THE  STAR

# RESPONSE TO SUBMISSIONS

## MODIFICATION 13 TO MP08\_0098

*NOVEMBER 2018*

Figure 2 – The Neighbourhood Centre

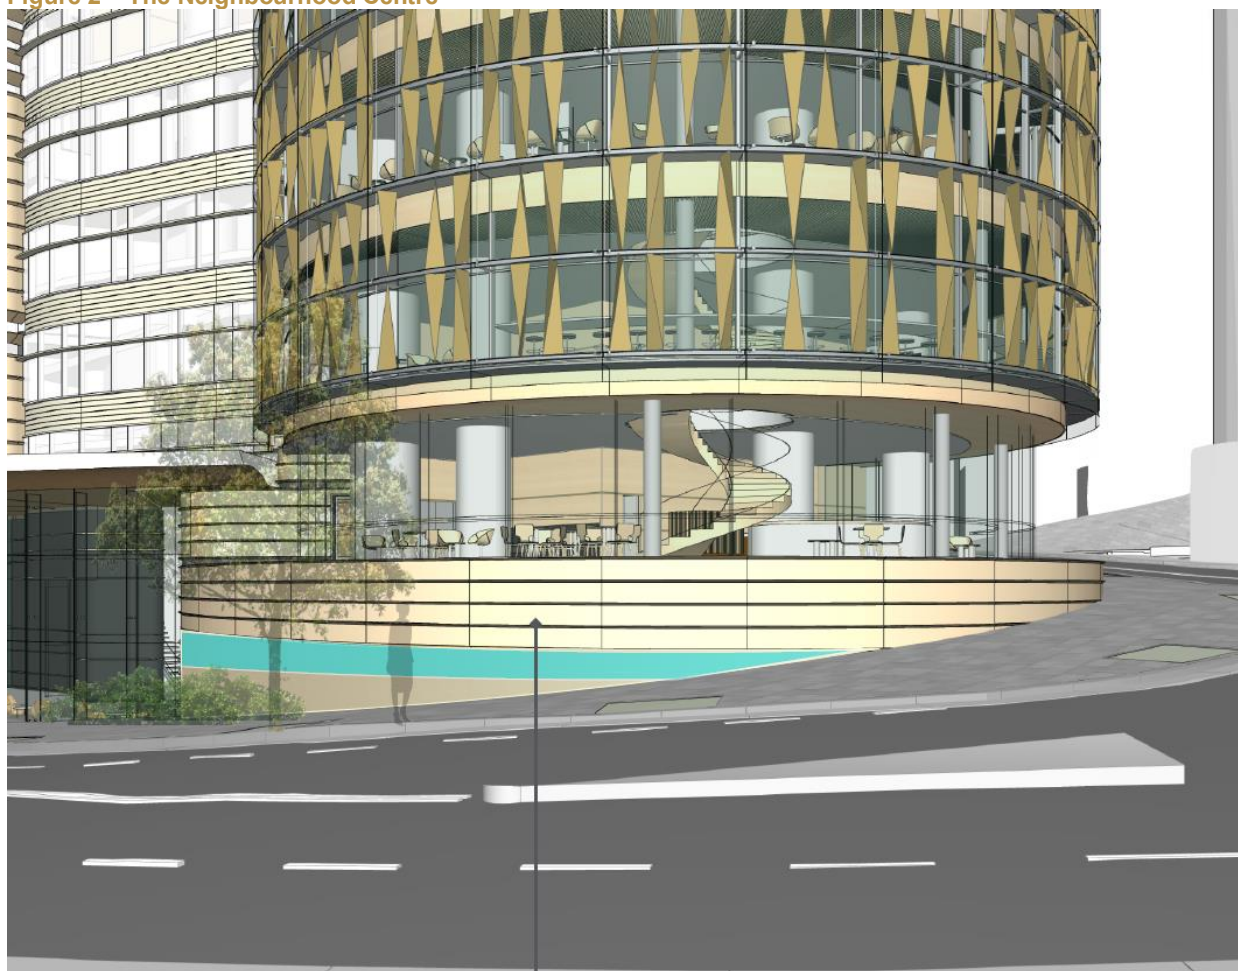
FJMT have reviewed the opportunity to provide stairs wrapping around the corner of Pirrama and Jones Bay Road within the site. This would result in a smaller and compromised layout of the café and removal of or significant decrease in the potential to provide planting within the terrace area. Given the slope of the land as it wraps around the corner it will still be necessary to include a wall element wrapping around the corner. The entry to the Neighbourhood Centre remains on the Jones Bay Road, consistent with that shown on all of the earlier schemes separating that entry from the Hotel and Casino entries fronting Pirrama Road and placing it adjacent to the residential lobby entrance of the tower.

To address the concerns regarding presentation and materiality to the intersection FJMT explored to which would soften the presentation to Pirrama Road and maintain the functionality of the café space. This is represented in **Figure 2**.

Material change - extend sandstone to base.  
Integrated (recessed) display case / signage  
zone as related to neighbour centre

Figure 5 – Proposed new ramp to existing carpark showing internal clearance heights

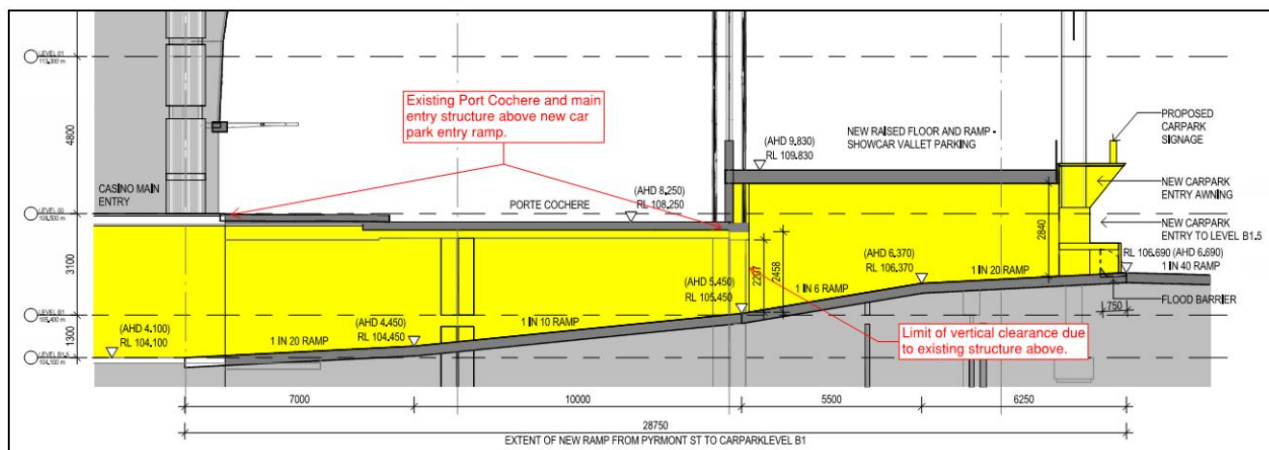
The flood gate will be installed within the boundary of the development site and not within the Council footpath. The operation and maintenance and testing will be the responsibility of the developer (Star Entertainment Group Limited) and has a 100 year design life and requires minimal maintenance.

Details of the proposed gate combined with an addenda report prepared by TTW are provided in **Appendix P**.
